Re: St. Lucie Unit 2  
Docket No. 50-389  
Proposed License Amendment  
EDG Risk Informed AOT Extension  
Response to Second Request for Additional Information

Request for Additional Information  
Related to the Amendment of the Technical Specifications  
for the Emergency Diesel Generators  
St. Lucie Units 1 and 2

Response 9 for Unit 2 Cable Spreading Room and Control Room:

**FIGURE 1**  
**Blackout Crosstie Bus Arrangement**

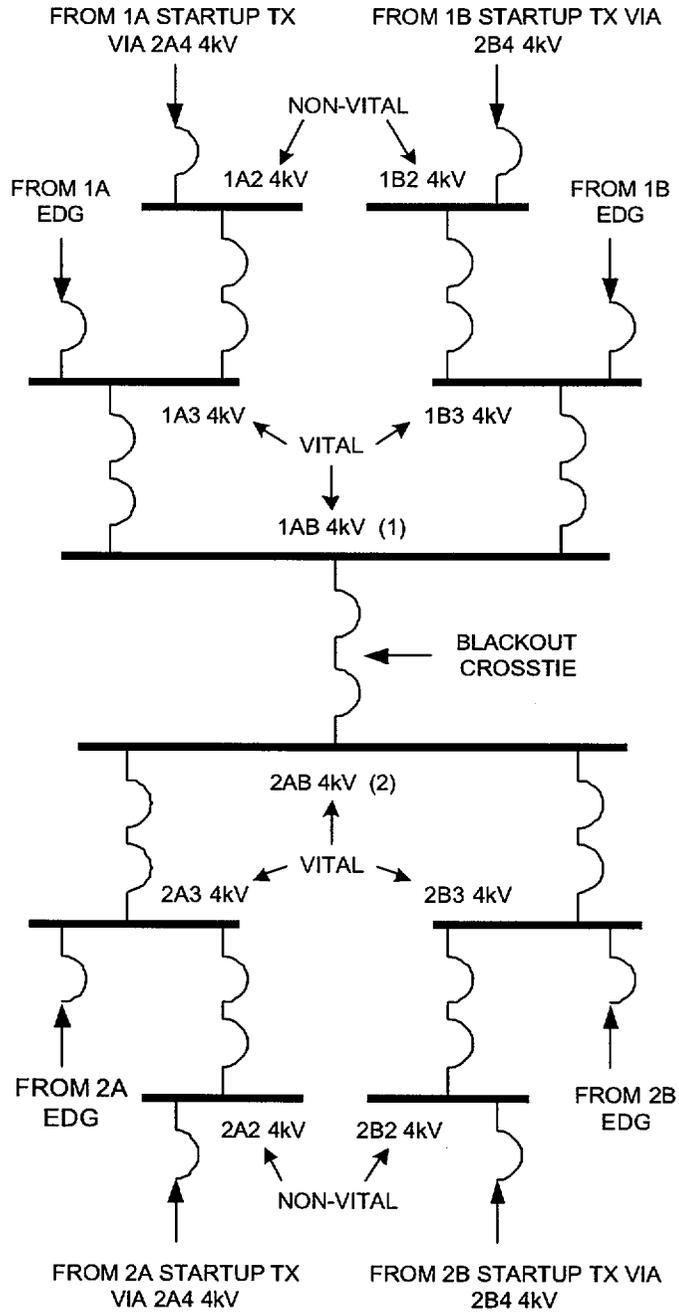
*Your submittal indicated that it was "judged" any potential risk impact of the proposed change due to internal fires would be "very small." Later, there was a small discussion on your off-normal operating procedures in response to fire; however, no further specific discussions were provided to justify the conclusion that the risk impact of the change would be small. Meanwhile, your IPEEE submittal estimated that the core damage frequency (CDF) due to fire was  $1.9E-4/yr$ , which was significantly higher than the CDF due to internal initiating events. There were three rooms that were screened in for detailed evaluations, which include control rooms, cable spreading rooms, and 'B' switchgear room. Please justify your conclusion by describing your technical basis for the judgment that the risk impact due to fire would be very small in terms of risk measures, i.e., change in CDF and incremental condition core damage probability (ICCDP) for a single 14-day outage, used in Regulatory Guides (RG) 1.174 and RG 1.177.*

The St. Lucie probabilistic safety assessment (PSA) models used to calculate the estimated internal events risk impact of the proposed allow outage time (AOT) extension do not include an assessment of the potential risk due to internal fires. The following provides a scoping estimate of the impact on the fire risk due to the proposed AOT change. Note that the fire risk is only estimated for the preventative maintenance (PM) case since this would provide the greatest exposure to unavailability that might extend beyond the present 72-hour AOT. Figure 1 is a diagram of the St. Lucie Plant electrical distribution system showing the station blackout crosstie arrangement.

The approach to the assessment relies on the redundancy that is an integral part of the plant design basis. Each of the safety-related electrical distribution buses is provided with an offsite supply and a dedicated onsite EDG. A crosstie to the other unit is also available but not credited in the CSR analysis. Each of these sources is available to support plant system needs following a postulated fire induced plant trip. Assuming a postulated fire event does not impact any of these three power sources, the conditional core damage probability would be dominated by random failures of the mechanical front line systems. Based on this insight, the assessment for the cable spreading room and main control room considered the following general steps.
